ADDENDUM NO. 1

TO: PLANS AND SPECIFICATIONS FOR STATE OF MISSOURI

Remodel Space for Printshop Utilization
Scruggs Station Warehouse
Jefferson City, Missouri
PROJECT No.: O2544-01

M101

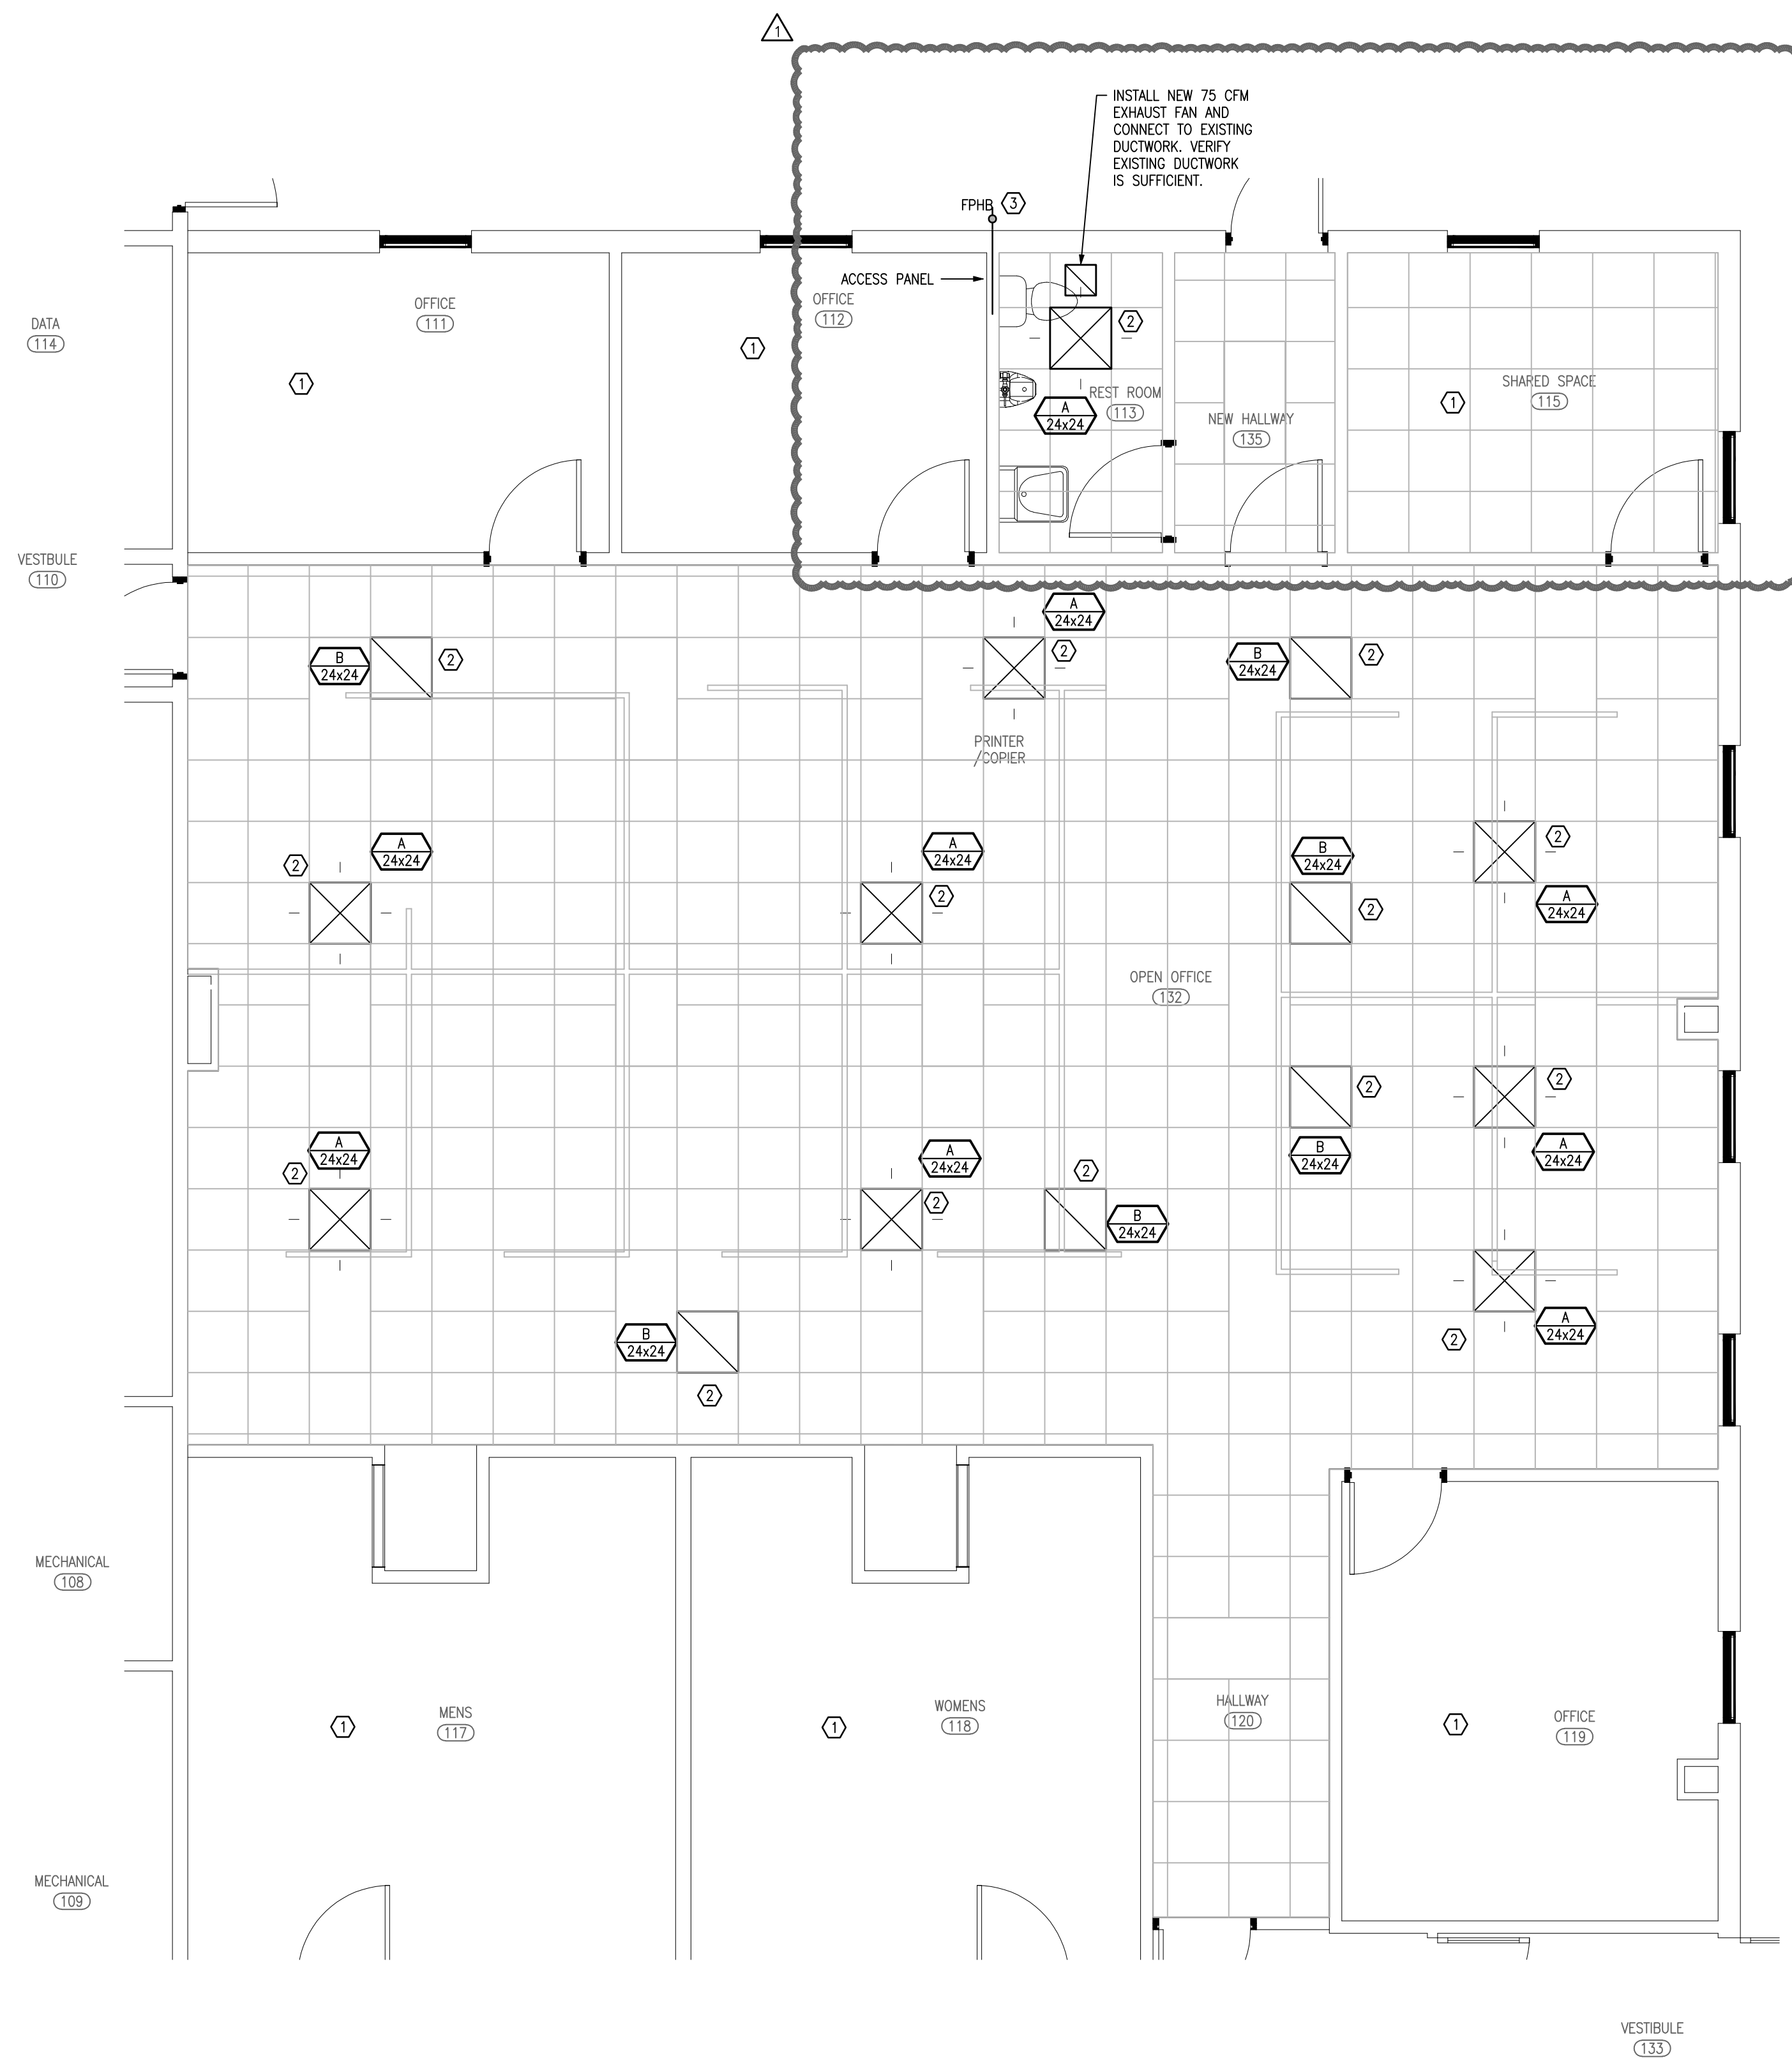
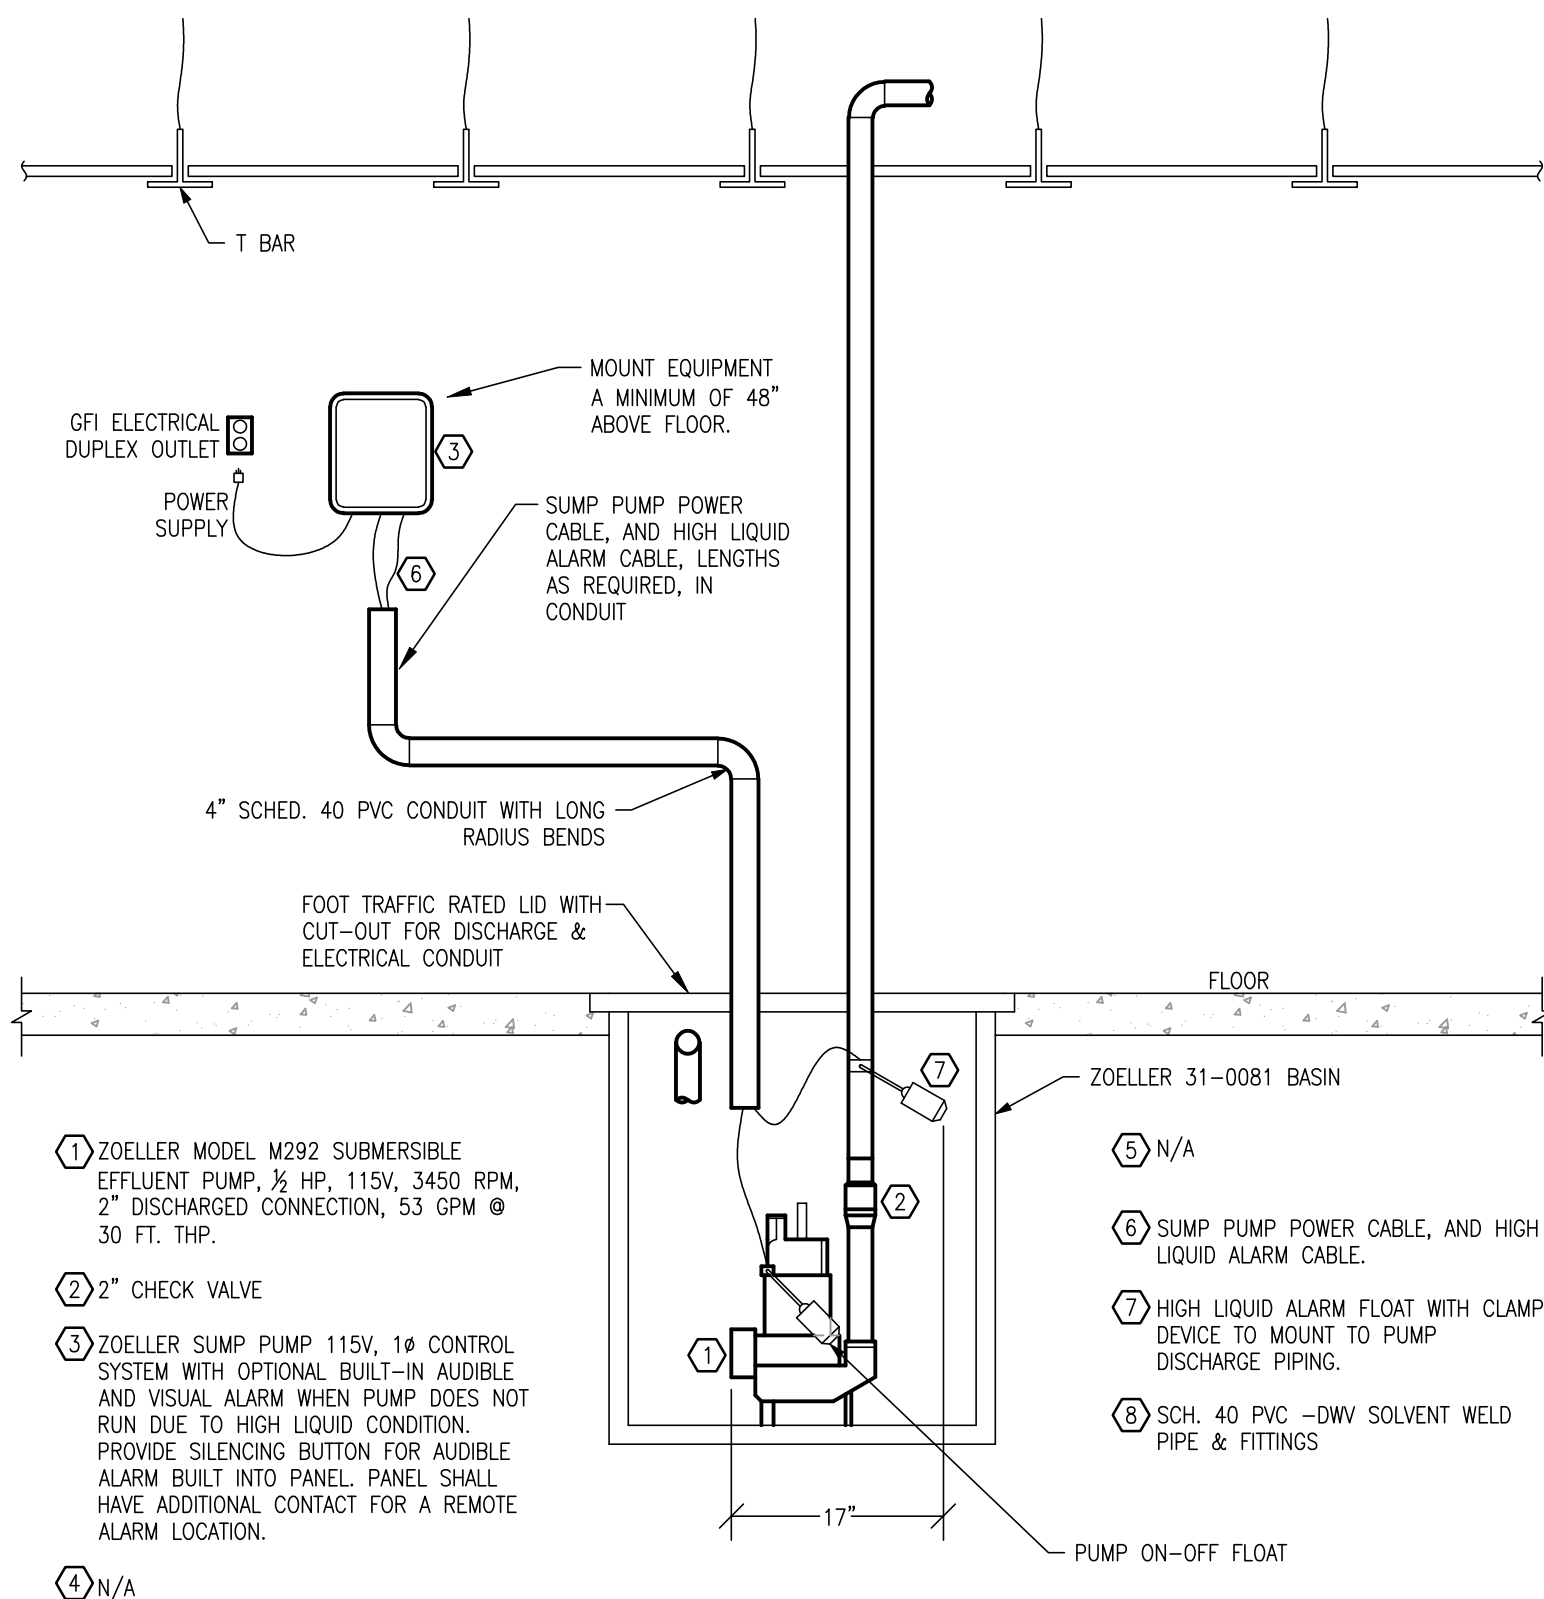
6. **Sheet M101:** (full sheet re-issued)
 - a. Add exhaust fan to Restroom 9-03
7. **Sheet ME102:** (full sheet re-issued)
 - a. Add compressed air piping detail

M103
SHEET 24 OF 28

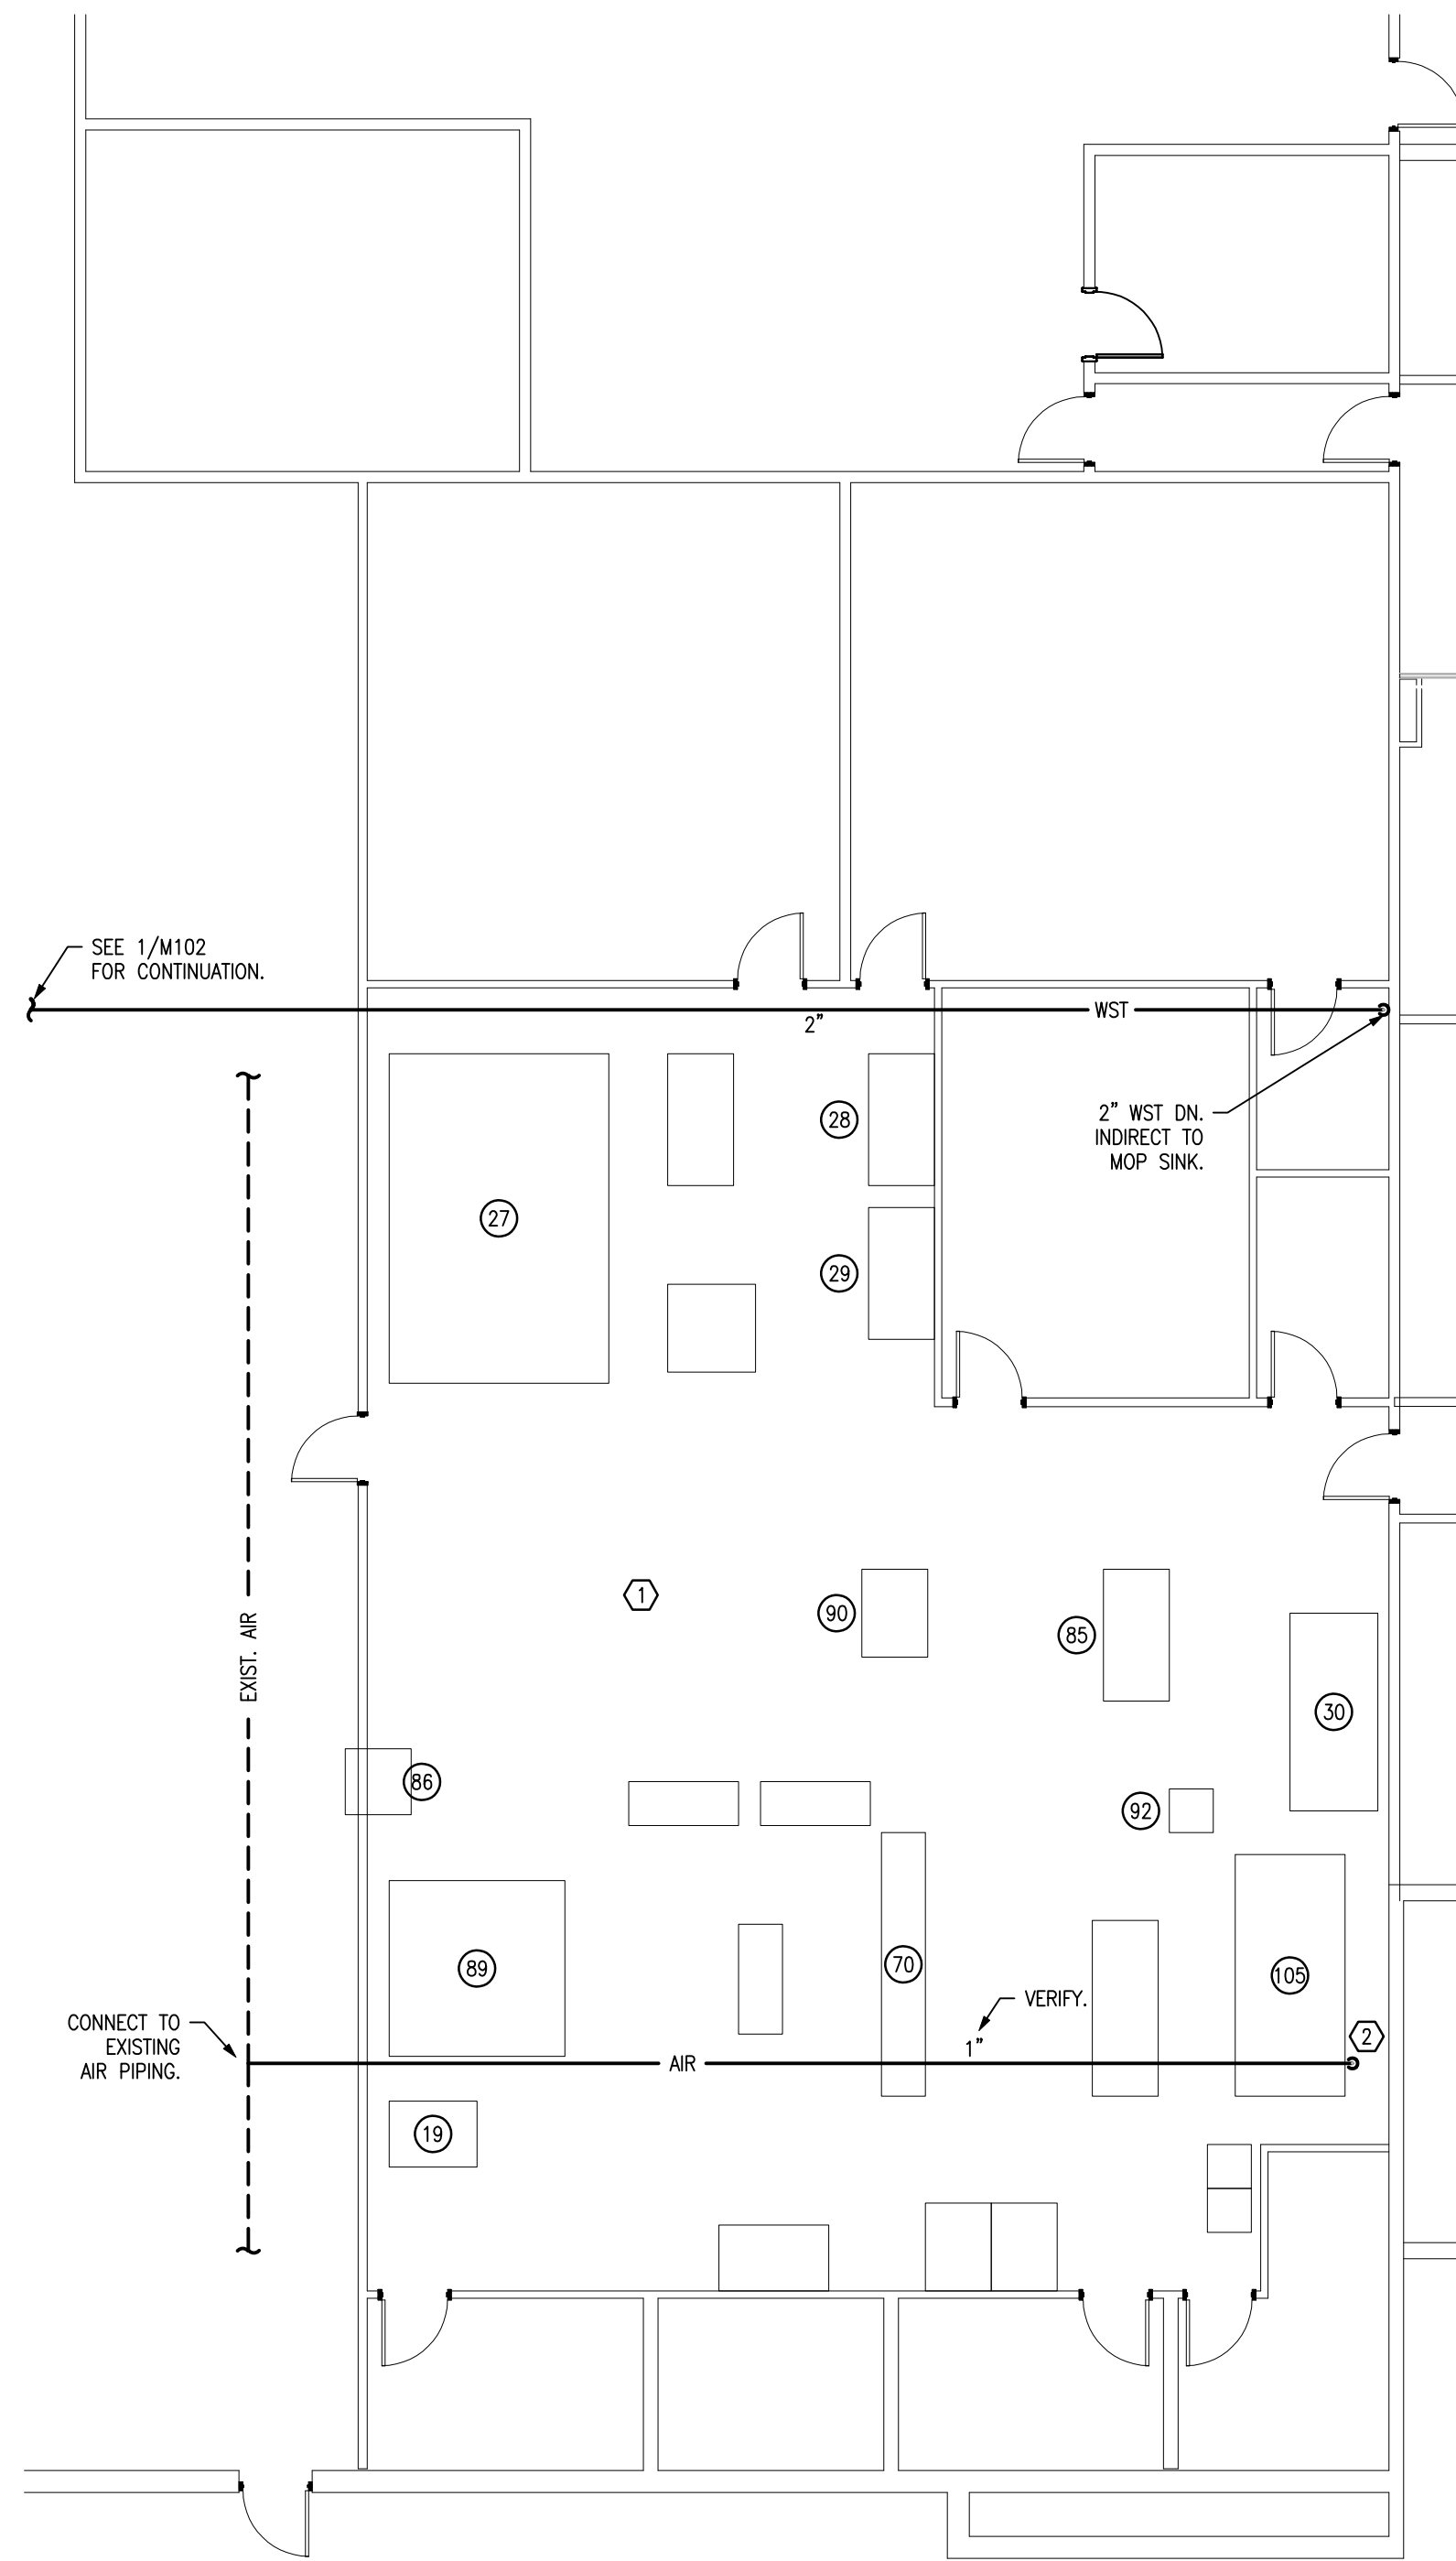
8. **Sheet M103:** (full sheet re-issued)
 - a. Updated architectural background
9. **Sheet E101:** (full sheet re-issued)
 - a. Updated architectural background
